RHODE ISLAND CONTRACT NO.2019-CH-031

**Blackstone River Bikeway Repairs**

NOTICE TO PROSPECTIVE BIDDERS

ADDENDUM NO. 1 Prospective bidders and all concerned are hereby notified of the following changes in the Plans, Specifications, Proposal and Distribution of Quantities for this contract. These changes shall be incorporated in the Plans, Specifications, Proposal and Distribution of Quantities, and shall become an integral part of the Contract Documents.

**GENERAL PLAN &  
PROFILE NO. 13**

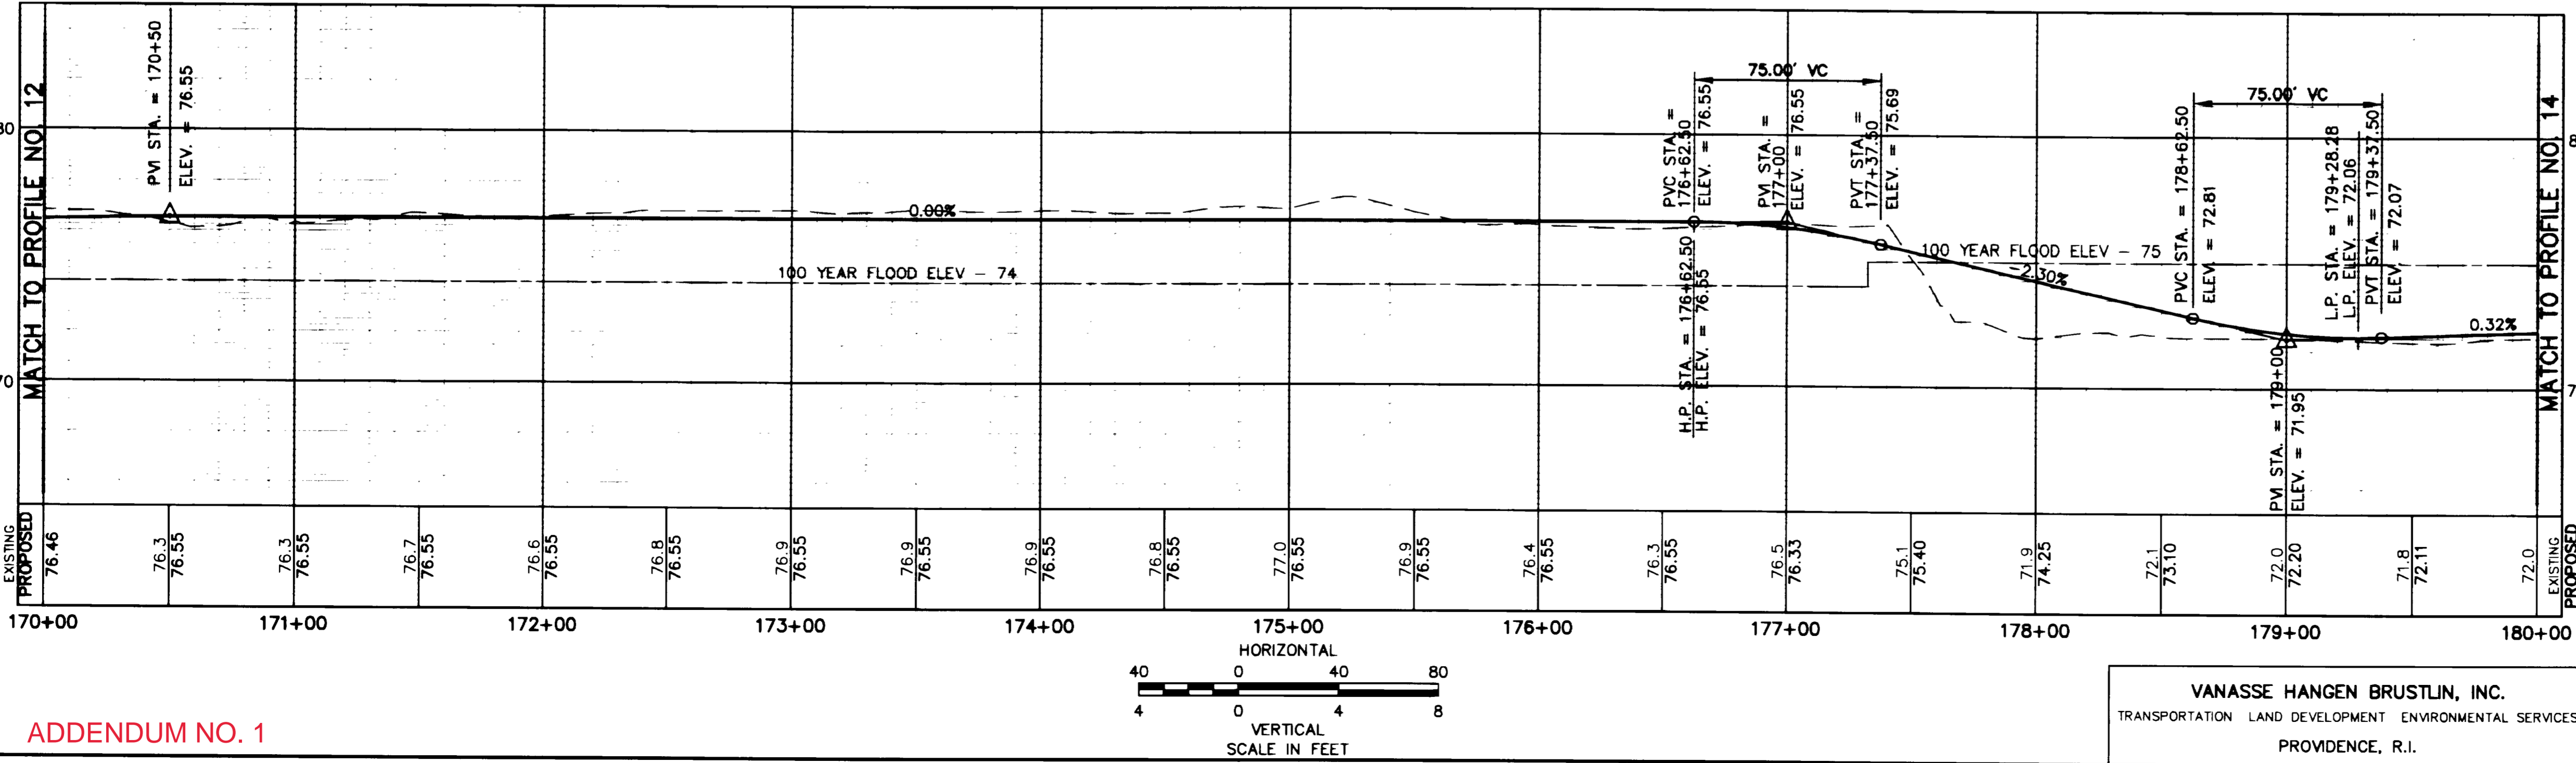
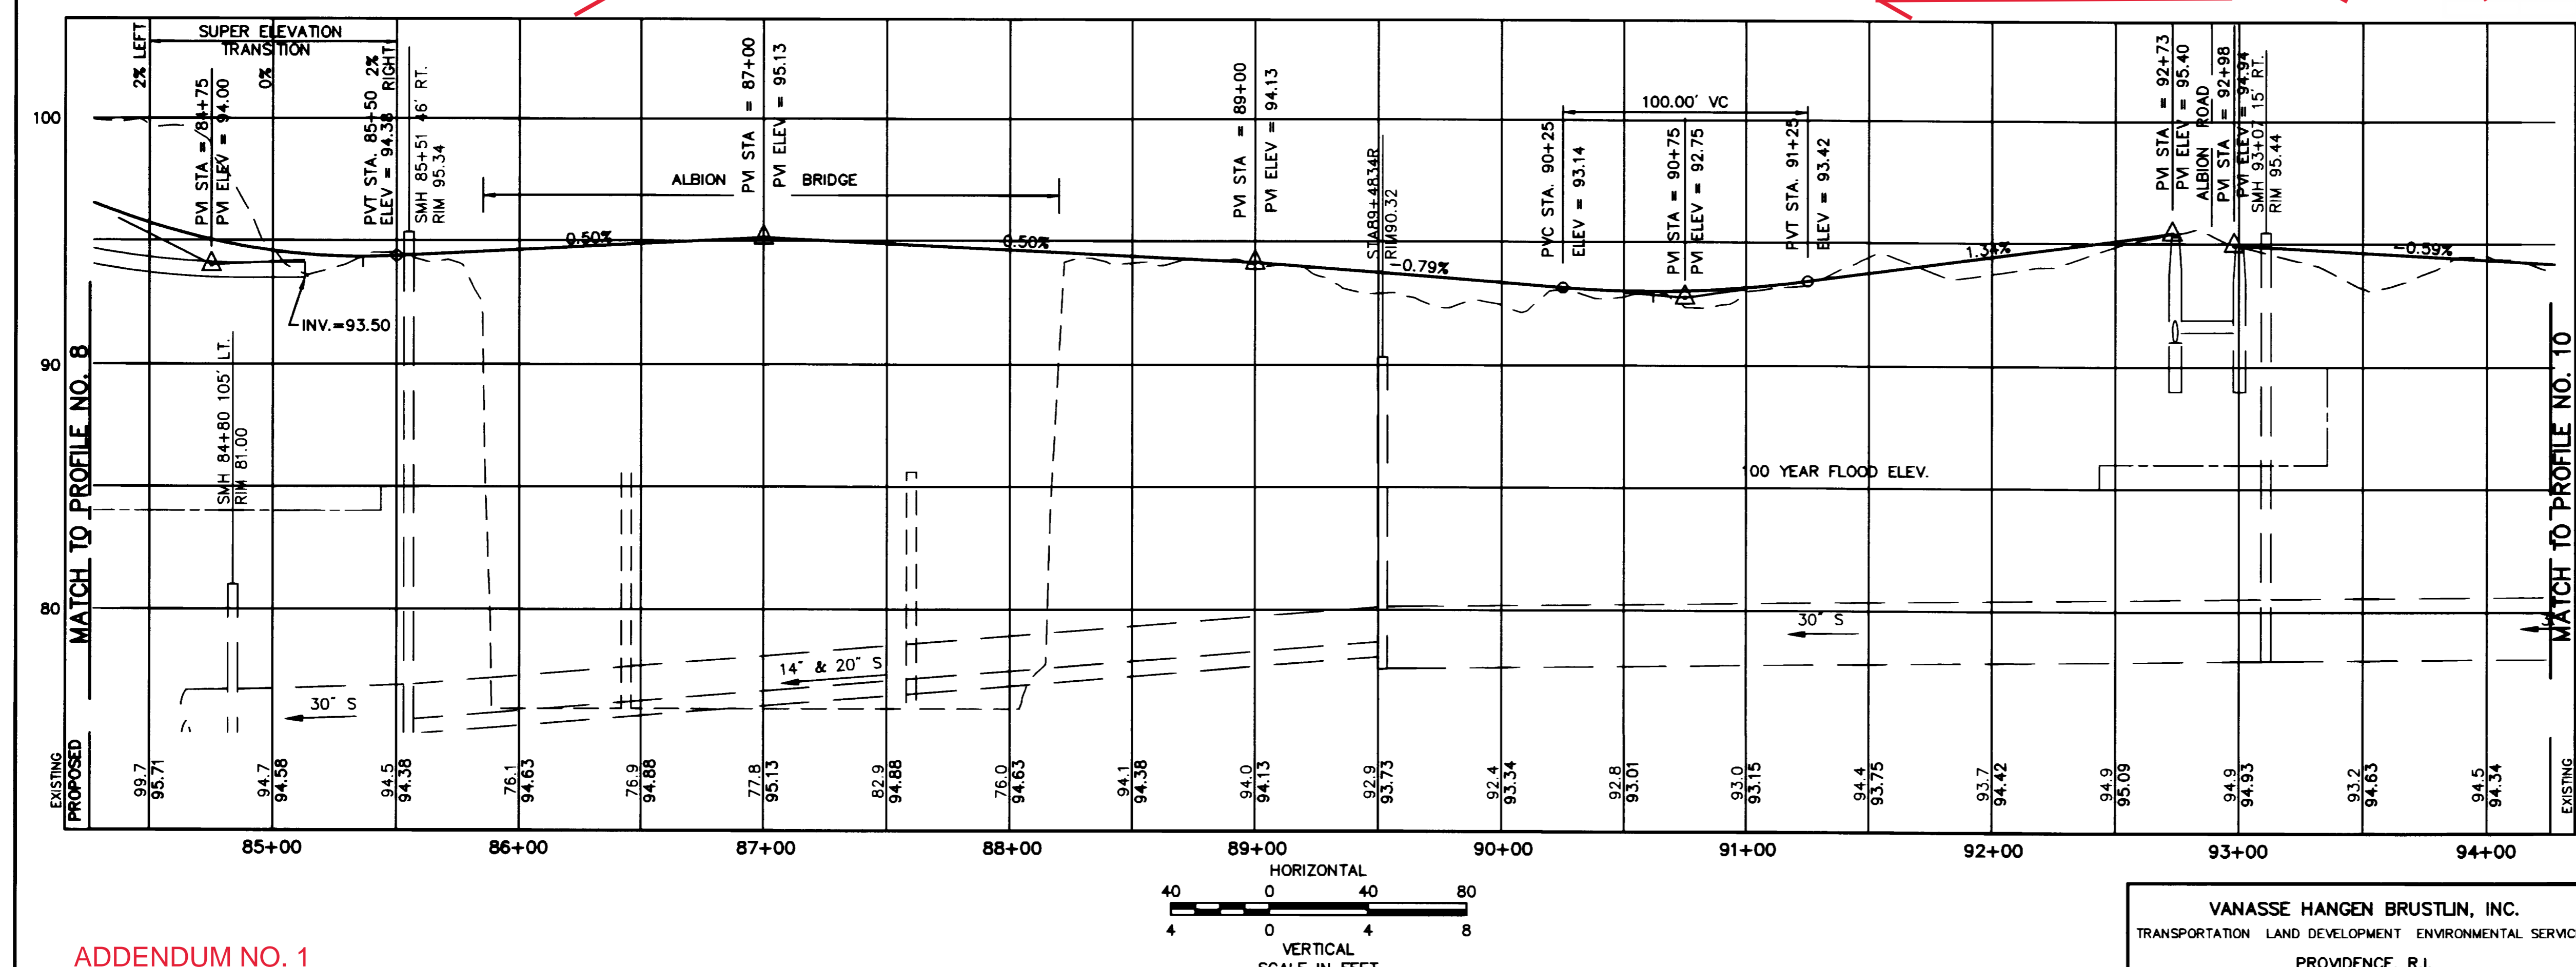
1. Volume 2 – Blackstone River Bikeway Segment 5: RIC 9750  
General Plan and Profile No. 13 – Delete Sheet 18 in its entirety and replace it with revised Sheet 18 (R-1) attached to this Addendum No. 1. The length of repair work at station 174+50 has been revised.
2. Volume 2 – Blackstone River Bikeway Segment 6: RIC 2000-CH-045  
General Plan and Profile No. 9 – Delete Sheet 15 in its entirety and replace it with revised Sheet 15 (R-1) attached to this Addendum No. 1. The length of repair work at station 91+00 has been revised.
